CHANGE ORDER NO 1 (#2005.010)

**WORK CHANGE DIRECTIVE
(Change Order)**

PROJECT: Minden-Tahoe Airport, AIP Nos. 3-32-0013-13 and 14

**MINDEN-TAHOE AIRPORT
AIP 13 & 14 CONSTRUCTION**

HUTT LEASE #1 AT AUTO GATE

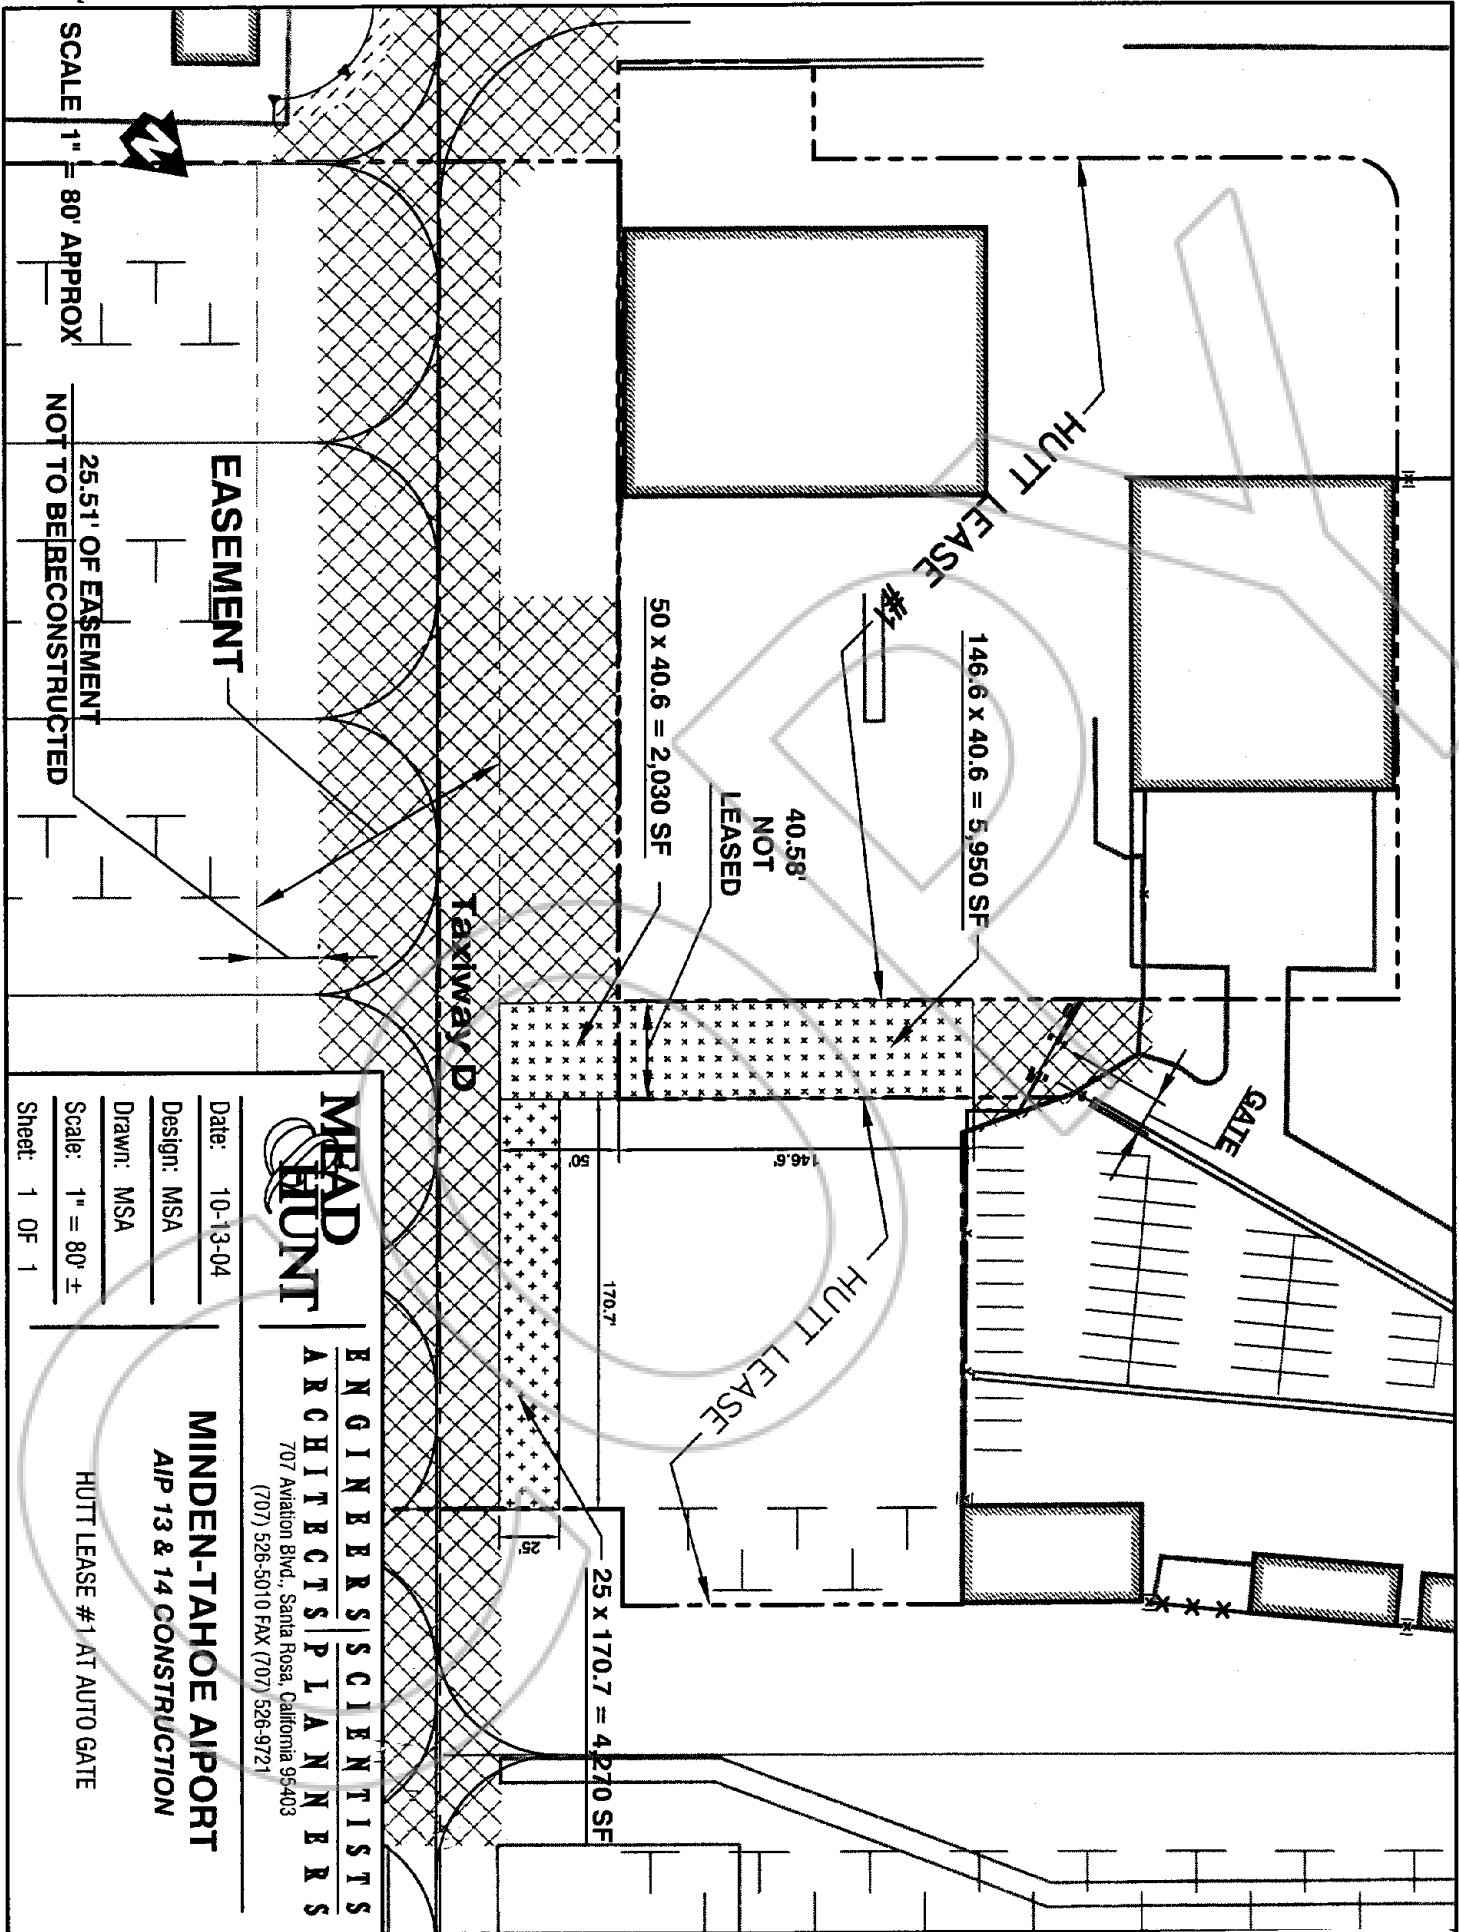
Expand Taxiway D Reconstruction Area. This change increases the Taxiway D work area by approximately 12,250 square feet as shown on the attached exhibit drawing. Included in the scope of new work are providing temporary access to Hutt Aviation, site preparation, demolition, pavement pulverization, earthwork, cement treatment and paving. Required adjustments to contract quantities and new pay items to cover the additional costs of the new work are as shown below.

Reason for Change: The pavement in the expansion area is failed and needs to be reconstructed to correct drainage problems that have caused severe surface distress and pavement failures. If left uncorrected, the drainage problems will have adverse effects on the adjacent new pavement. This change increases the Contract by \$66,760.00.
